Docket Item # 5  
BAR CASE #2010-0316

**ISSUE:** Alterations (Door Replacement)

**LOCATION:** 111 Pommander Walk Street

Figure 1: Fiberglass door at 111 Pommander Walk Street

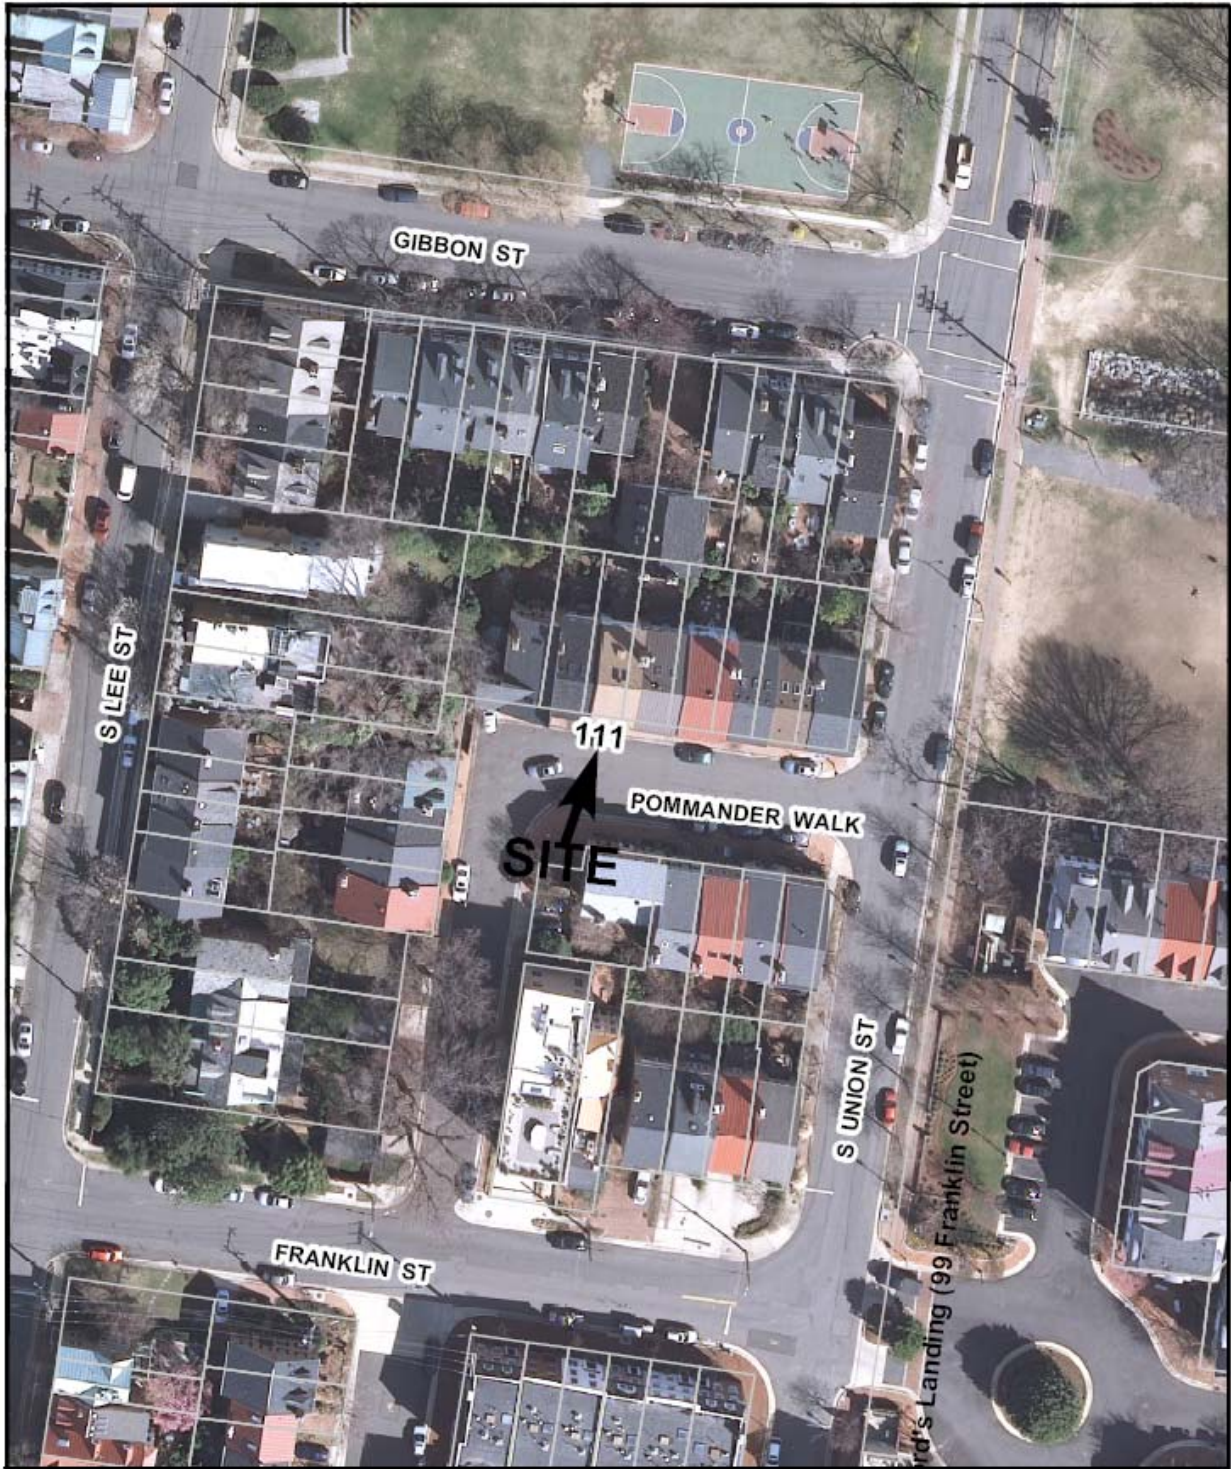
The applicant is requesting after-the-fact approval of a Certificate of Appropriateness for a painted fiberglass door at 111 Pommader Walk Street. The six panel, field painted fiberglass door has glazing in the two upper panels. The applicant has stated that the past two wood doors installed by the applicant have warped and cracked due to the southern exposure of the townhouse. The smooth fiberglass door was manufactured by Therma-Tru.

The Board has maintained in the past that a front door is regularly used by residents and their guests and should be constructed of natural materials because this tactile quality is important in a historic district – even on modern buildings. However, Staff conducted a site visit to the property and found the smooth fiberglass door to be nearly indistinguishable from a field painted wood door. Although Staff has been told that there are a number of other townhomes in this immediate area that have fiberglass doors, they are visually difficult to locate when they have been field painted. Even the “stained” woodgrain fiberglass doors now promoted by some manufacturers are difficult to distinguish in the field, although these would not be recommended by Staff because stained wood doors were not historically common until clear finishes that could withstand weather were invented in the 20<sup>th</sup> century. From what research Staff has done thus far, high-quality fiberglass doors can be molded to have the same crisp lines and panels as wood doors, yet have greater lifespan and increased thermal efficiency. Because they are filled with foam, they have a density and sound very similar to wood when one knocks on them. Staff also notes that high quality versions of these doors are not inexpensive and should be more durable than doors constructed of modern, fast growth

However, Staff has found that the use of glazing within fiberglass doors is less convincing due to the fact that the trim piece necessary to frame the thicker insulating glass is unusually large and out of character with historic wood doors. In addition, the leaded and stained glass panels offered by manufacturers are often inappropriate to the architectural style of the door or the dwelling. Staff will continue to research the topic of fiberglass doors and may ultimately recommend that the Board adopt a policy which allows for the installation of high-quality fiberglass doors, which have no glazing and are field painted, although **only** for buildings post-dating 1965, when fiberglass doors became commercially available in the U.S.

Given the age of the building and the variety of door styles and materials within the late 20<sup>th</sup> century Pommander Walk development, Staff believes the proposed 6-panel, Colonial Revival style door is high quality and compatible with the other townhouses in the development. A site visit to the development reveals a significant variety of door styles (4-panel, 6-panel, imitation leaded glass), only a few of which were approved by the Board. Furthermore, the Board has already approved the use of synthetic materials within the development when they approved an AZEK door surround at 105 Pommander Walk Street in 2006 (BAR Case #2006-0295).

**STAFF RECOMMENDATION:** Staff recommends approval of the application as submitted.
